**BEFORE THE INDEPENDENT HEARING PANEL APPOINTED BY THE
QUEENSTOWN LAKES DISTRICT COUNCIL**

UNDER the Resource Management Act 1991 (RMA)
IN THE MATTER of the Te Pūtahi Ladies Mile Plan Variation in accordance
with section 80B and 80C, and Part 5 of Schedule 1 of the
Resource Management Act 1991.

**REPLY TO QUESTIONS ASKED OF ROLAND BRUCE HARLAND
24 November 2023**

Figure 1 – Possible change to Building Heights Plan

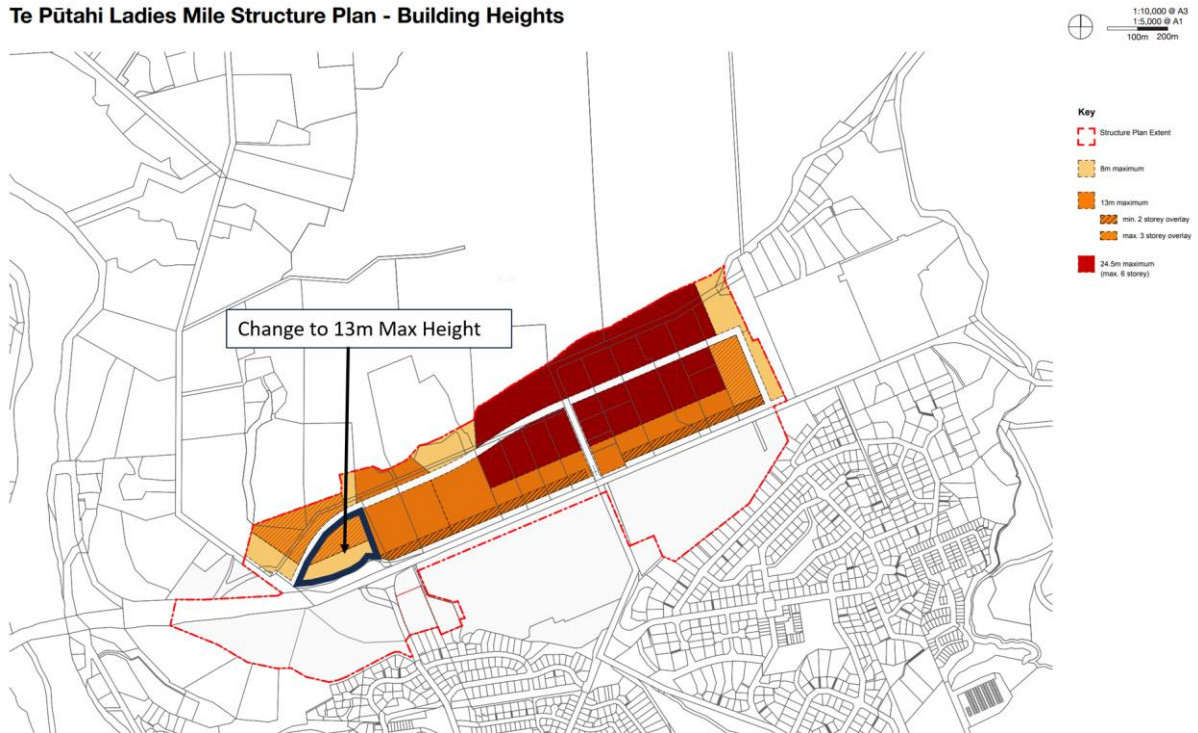
I note that the TPLM Variation as notified imposes an 8m height limit along a considerable portion of the Lower Shotover Road frontage and that it would be appropriate for this to be amended to allow higher buildings in the vicinity of the signalised intersection and proposed bus stops. I could support a change to the height limit to allow buildings up to 13m high between the Stalker Road roundabout to Collector Road Type A (refer to Figure 1 below). This would enable more flexibility for more intensity and higher built form in close proximity to the proposed bus stop.

Concept 1 – Retain Collector Road Alignment

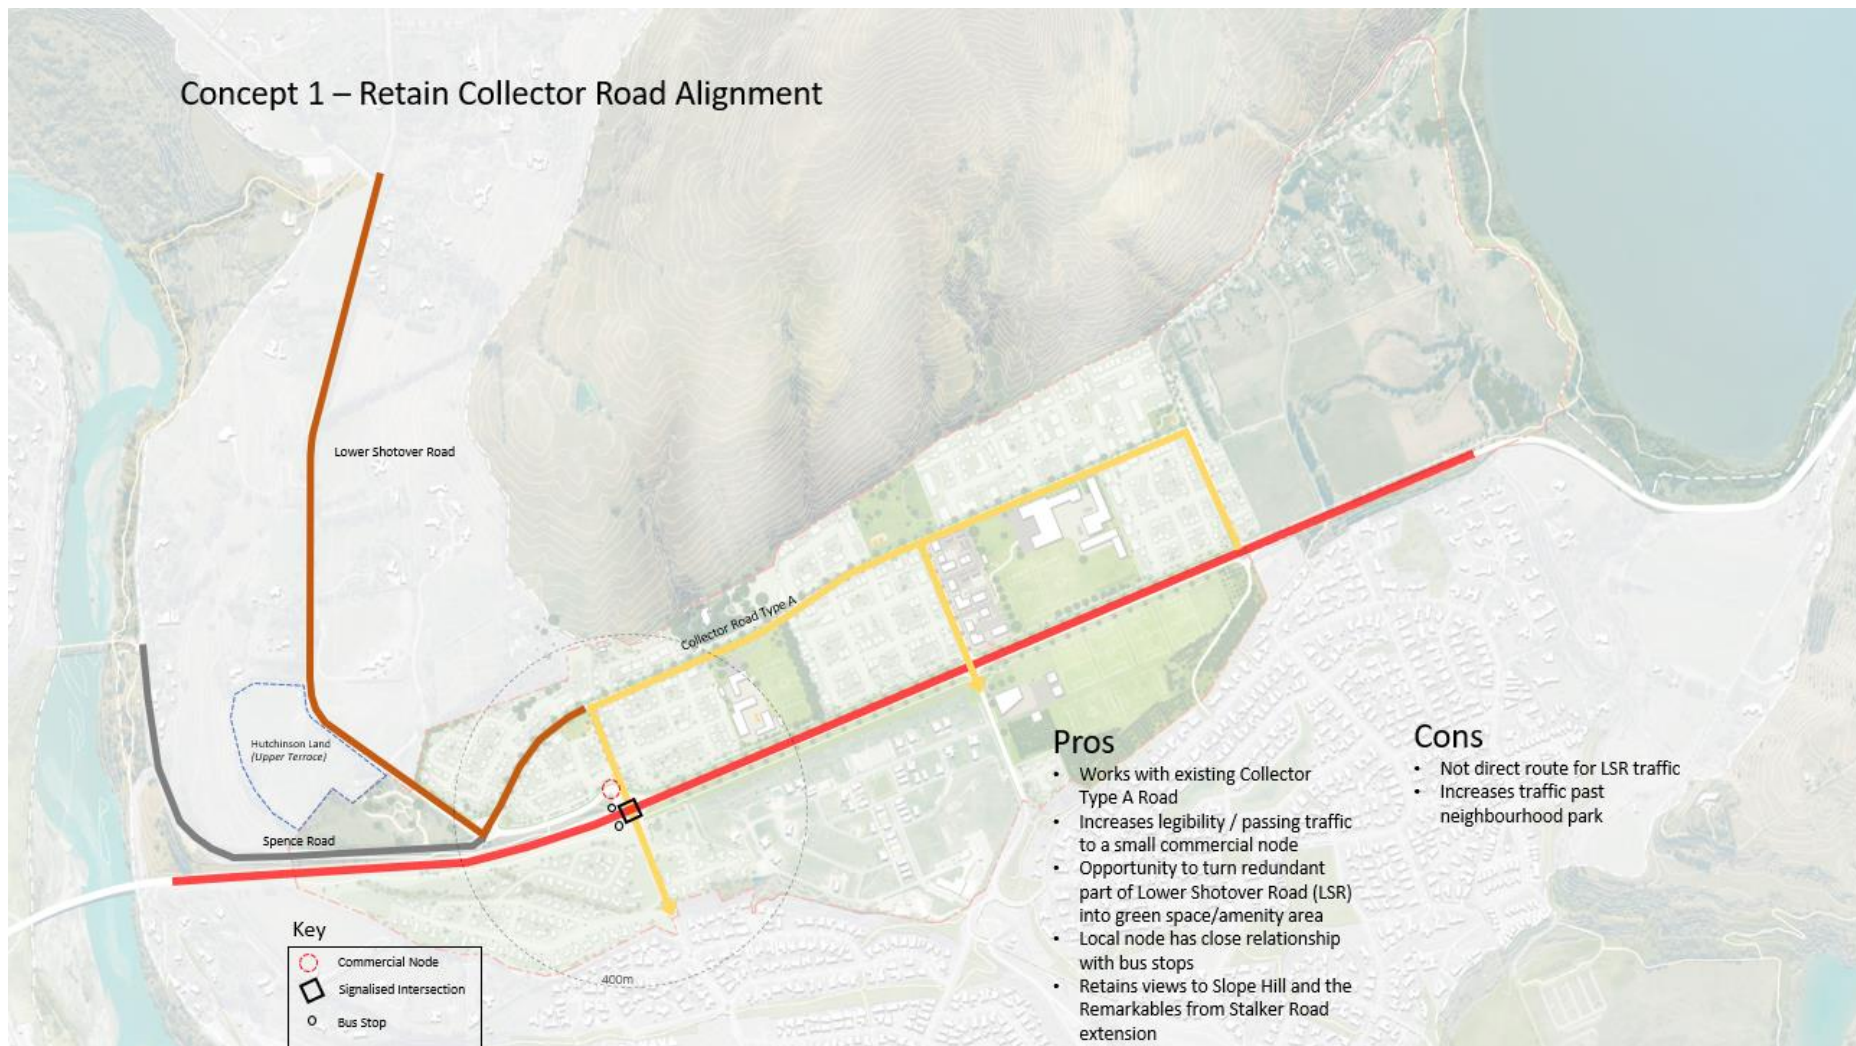
As identified in paragraph 31 of my rebuttal evidence and paragraph 31 of Stuart Dun's rebuttal evidence there are many issues and uncertainties that impact on an alternative layout to the western end of the Structure Plan should the Hutchinson land be included in the TPLM Variation. Key areas of uncertainty revolve around the design of a signalised intersection, location of bus stops and how Lower Shotover Road connects to SH6. It is not possible to come up with a definitive solution to this in the timeframe available given the many uncertainties, but I have considered a number of high level concepts which are illustrated below.

All three of these concepts are based on a northern extension of Stalker Road through a signalised intersection with SH6 and having the bus stops as close as possible to the western side of the intersection to minimise walking distance to access bus stops on either side of SH6. A small commercial centre is suggested on the north west side of the intersection which has a clear legibility in terms of the wider spatial structure and is well connected to the wider movement network including active travel and public transport. Any inclusion of the Hutchinson land should be limited to the upper terrace area, which is typically within a flat 10 minute walk of the public transit stop and should be of at least medium density to ensure higher use of public transport.

Concept 3 – Lower Shotover to Stalker Extension

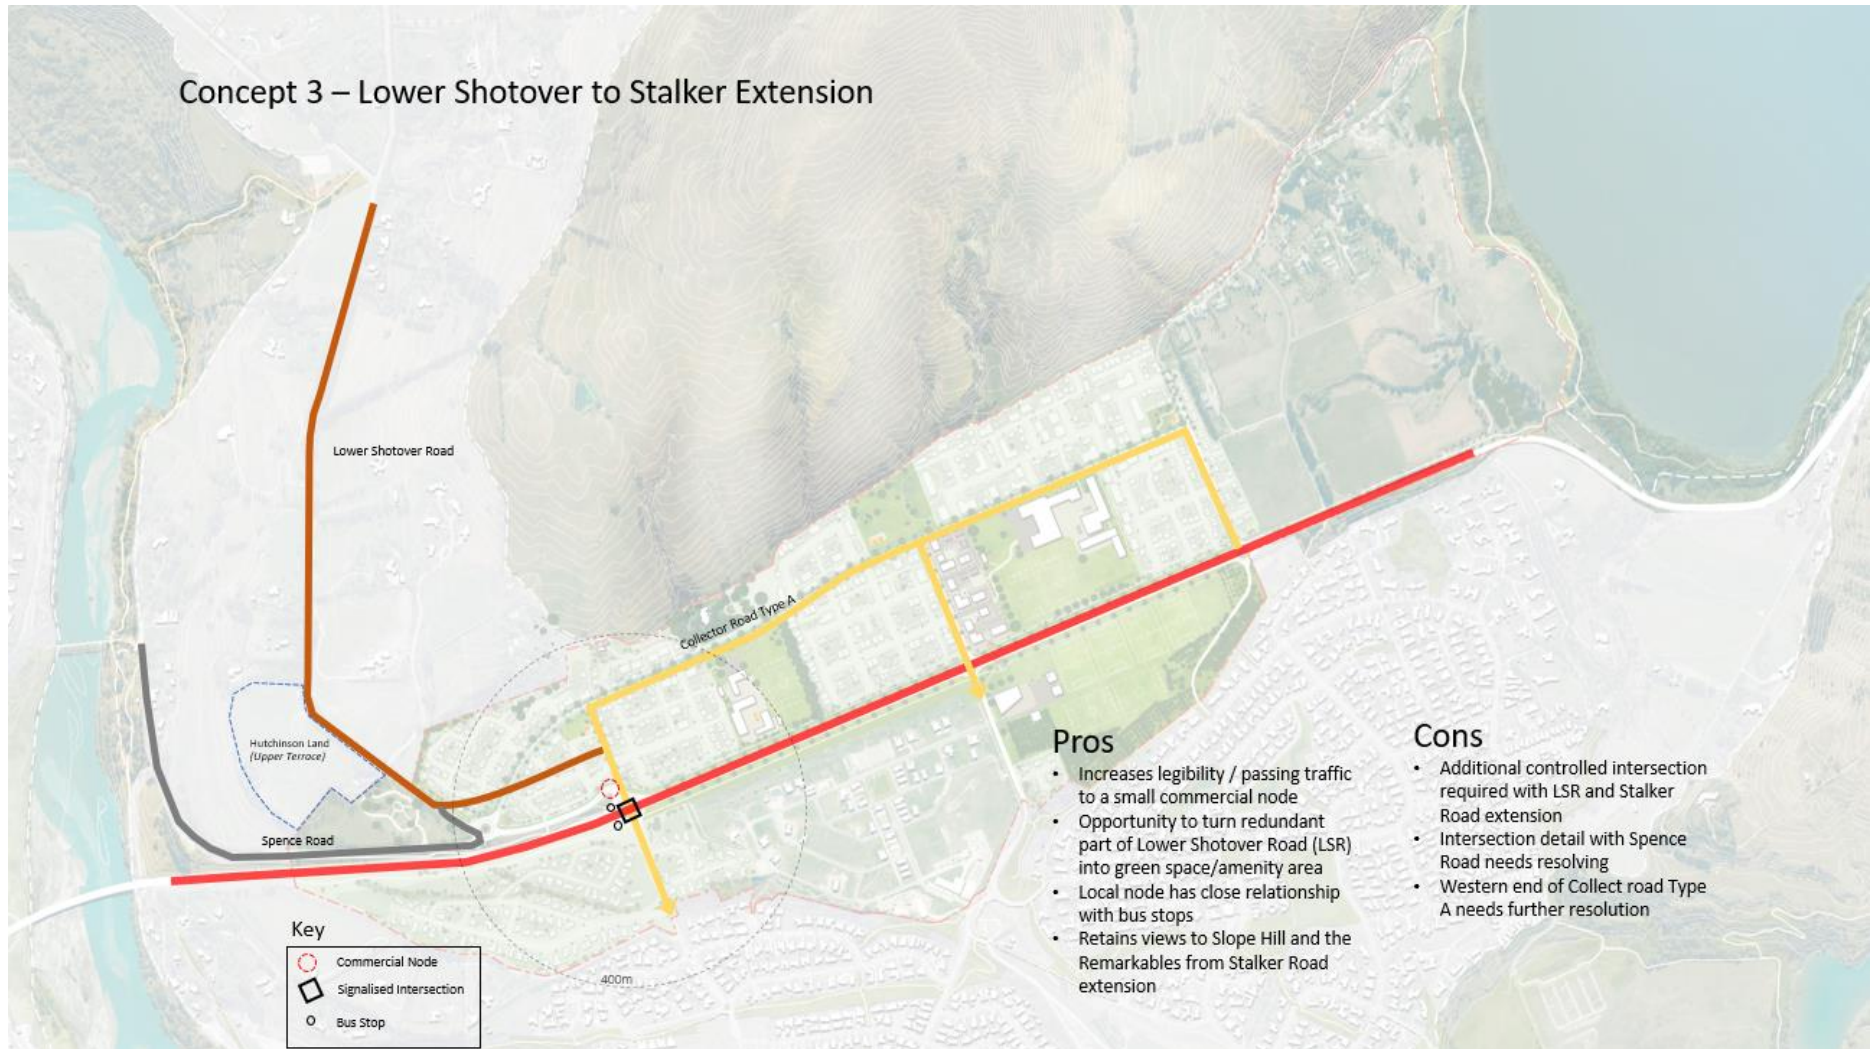
- Increases legibility / passing traffic to a small commercial node
- Opportunity to turn redundant part of Lower Shotover Road (LSR) into green space/amenity area
- Local node has close relationship with bus stops
- Retains views to Slope Hill and the Remarkables from Stalker Road extension

- Additional controlled intersection required with LSR and Stalker Road extension
- Intersection detail with Spence Road needs resolving
- Western end of Collect road Type A needs further resolution
